2 NUCLEAR REGULATORY COMMISSION

5 SUBCOMMITTEE ON PLANT LICENSE RENEWAL

6 + + + + +

7 WEDNESDAY, APRIL 1, 2009

Reactor Building Liner Corrosion

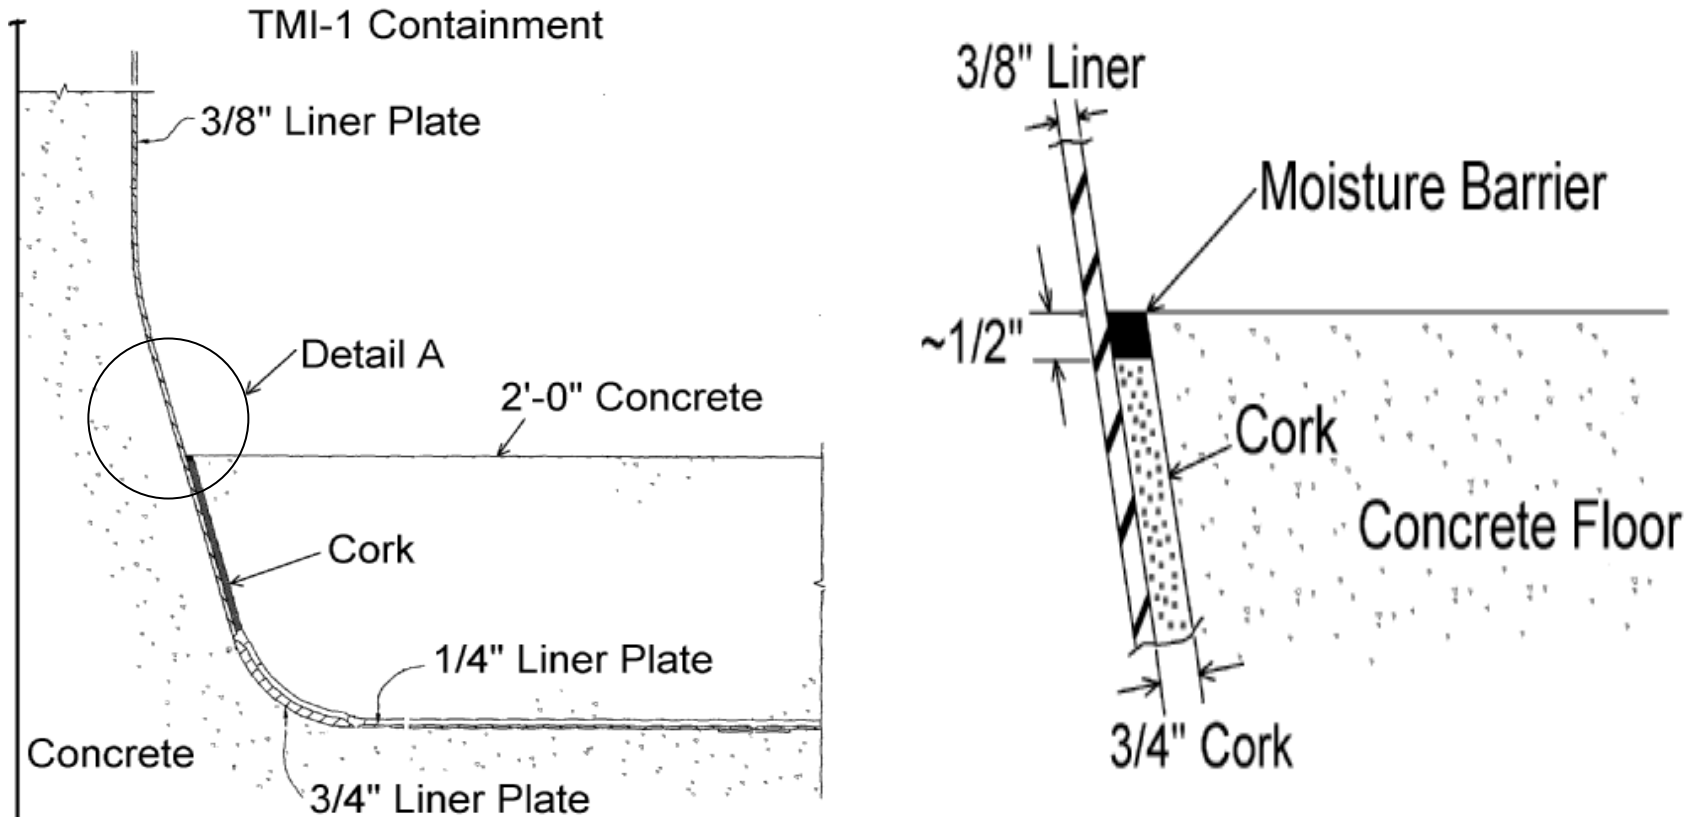
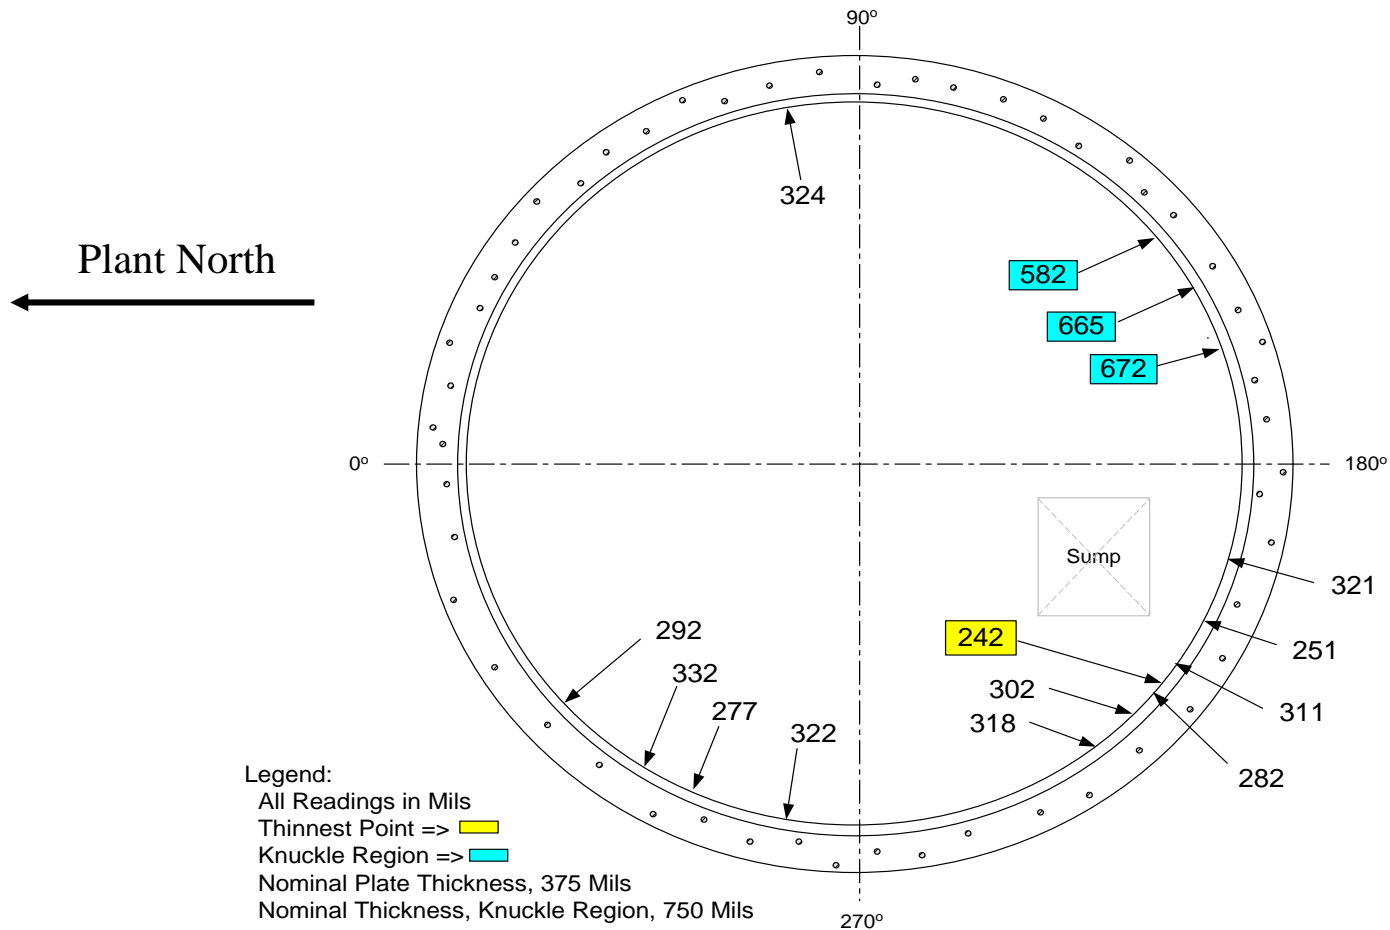
11 The diagram to the left shows the bottom
12 floor of the reactor building where it nears the wall
13 liner. The area of interest is Detail A, which you
14 can see to the right. You can see the carbon steel
15 liner with the moisture barrier taking up the gap to
16 the concrete floor slab. The combination of areas of
17 degraded moisture barrier with episodes of borated
18 water leakage were the cause of liner coating
19 degradation and the resulting corrosion.

20 Next slide is a plan view of areas where
21 we found the corrosion. This is a plan view of the
22 lower level of the reactor building. We removed the
23 moisture barrier during last outage in 2007 360
24 degrees around the reactor building and inspected
25 above, at and below the moisture barrier. We found no

22 MEMBER SIEBER: Yes. My question is though
23 from the boron that you found that caused the
24 corrosion of the liner where did it come from?

8 Our liner repair plan is to weld repair
9 any thinned area to establish all areas back to normal
10 thickness prior to the period of extended operations.

11 And that is scheduled in the fall of 2009 along with
12 our plant integrated leak rate test.

15 MR. NAVRATIL: Correct. So, yes. The
16 process will be to remove the moisture barrier, any
17 paint, clean up the surface for welding, perform NDE,
18 do welding and then perform more NDE and verify
19 restored thickness.

Fuel Storage Racks Containing Boral

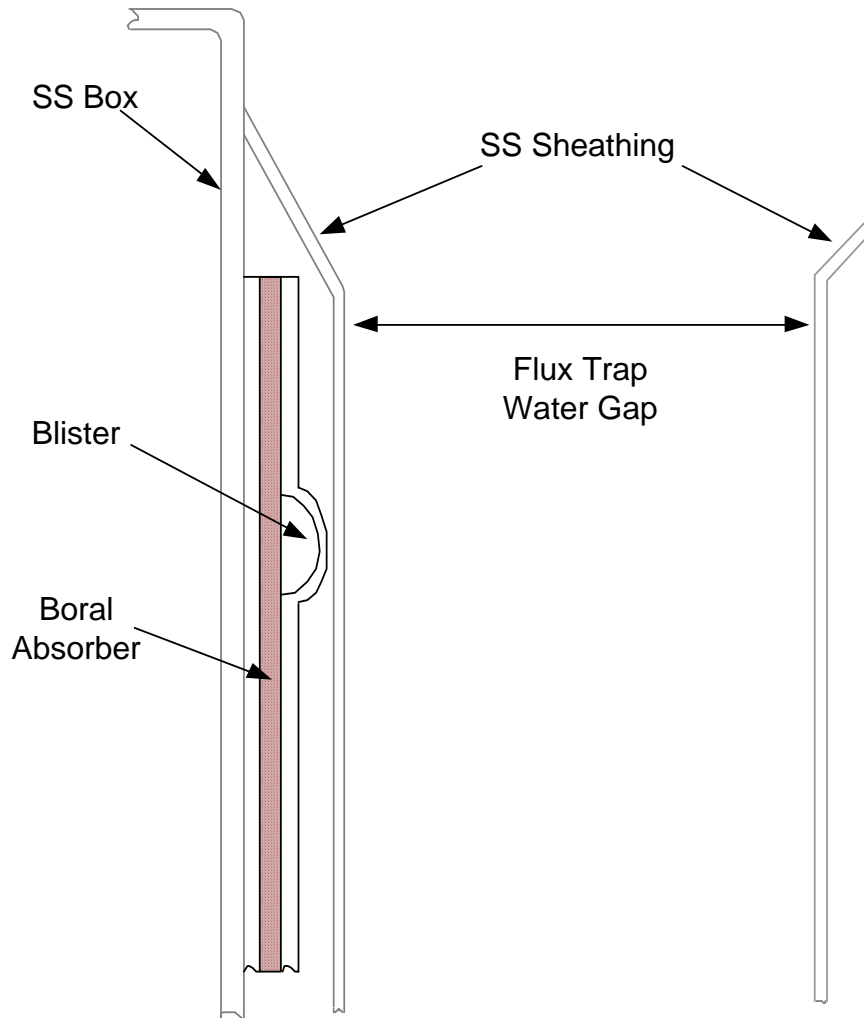
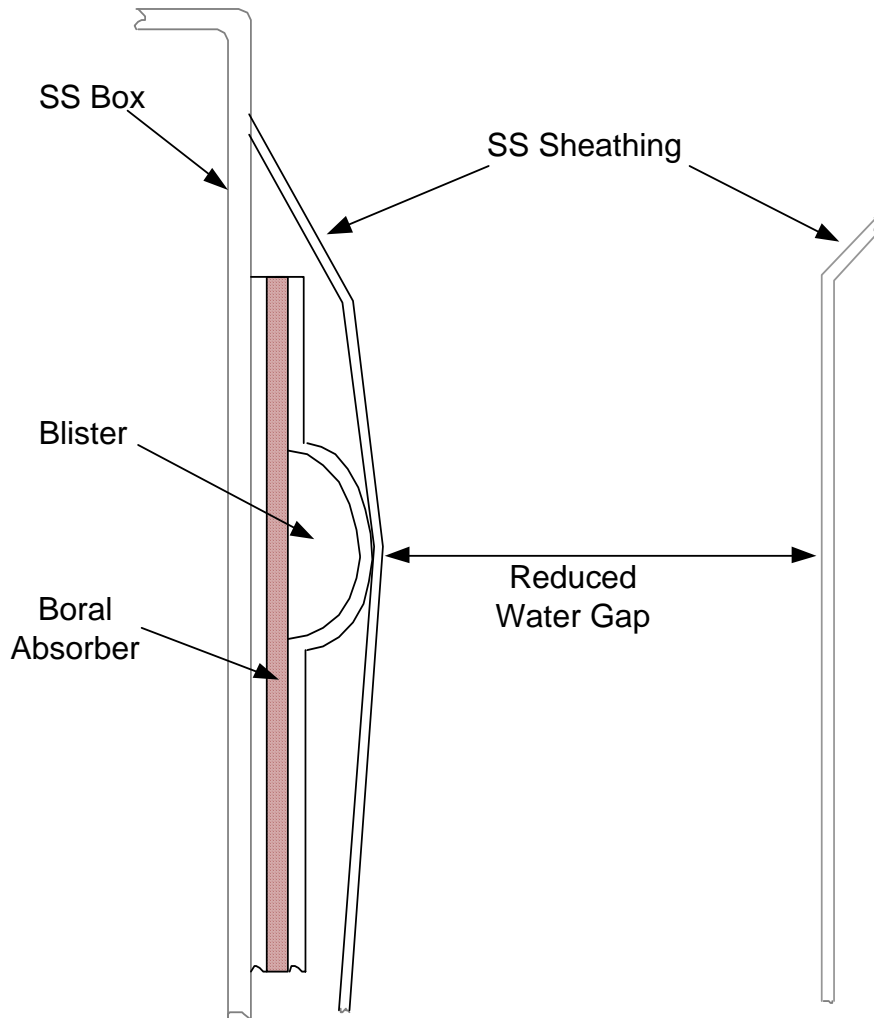
22 MEMBER ABDEL-KHALIK: Back to the
23 criticality calculations. What was the geometry for
24 that limiting case? How was that geometry modified,
25 that perturbed geometry that takes into account

11 MR. GETZ: We have not done an analysis
12 of, if I understand your question, how big a
13 deformation --

2 MR. GETZ: That's correct. If a blister
3 were to form on the panel that was gas filled, it
4 would effectively reduce the dimension of the water
5 gap. And our bounding example assumed a blister that
6 covers the entire surface.
